PLAN SNAPSHOT REPORT SP-2026-00020 FOR CITY OF ALBUQUERQUE

Description: Major Amendment to revise the northeast portion of Tract A-3-B to match the recent replat and to revise the overall parking calculations.

RE: Project No – 1010228; Major Amendment to a Site Plan – DRB

This amendment is based on the need to revise the property lot lines and the overall parking calculations and allotment for the restaurants on Tract A-3-B to match the recently approved replat (PR-2021-006236 / MINOR_PLT-2025-00049). This is responding to comments made by Jeff Palmer, City Code Enforcement, on the Capra Bank Phase 1 Site Plan:

Figure 1: Recently approved Plat

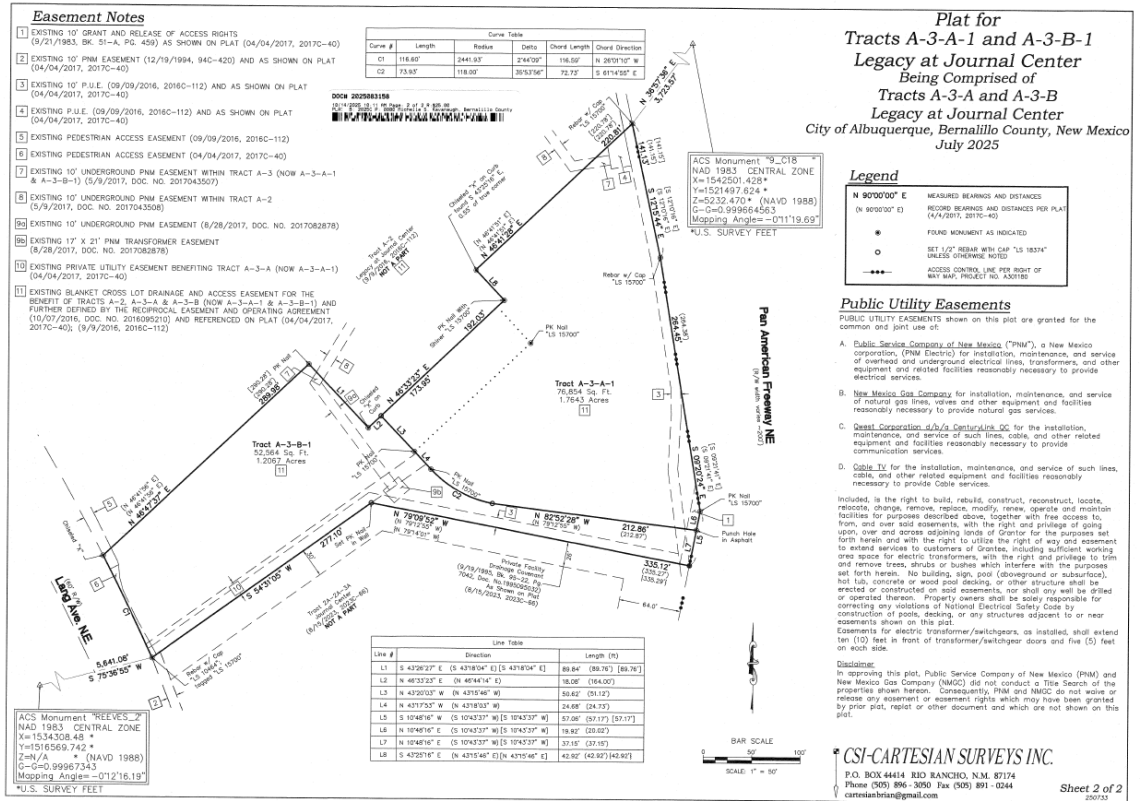
- Revision of property lines for A-3-B to match recently approved replat (see Figure 1). The northeast portion of A-3-B was replatted into A-3-A.

Figure 2: Marked-up Site Plan showing proposed minor amendments

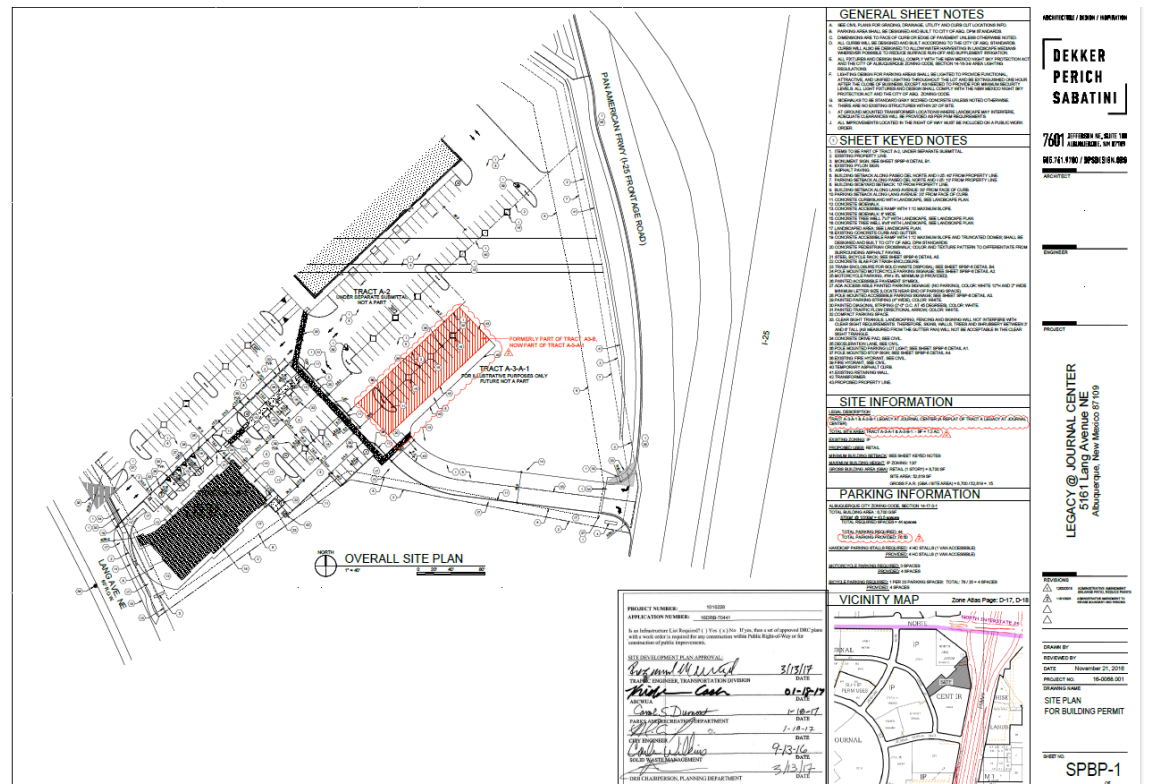
- Adjustment to parking allotment for the restaurants on A-3-B. From 44 required and 76 provided to 44 required and 50 provided (see Figure 2).
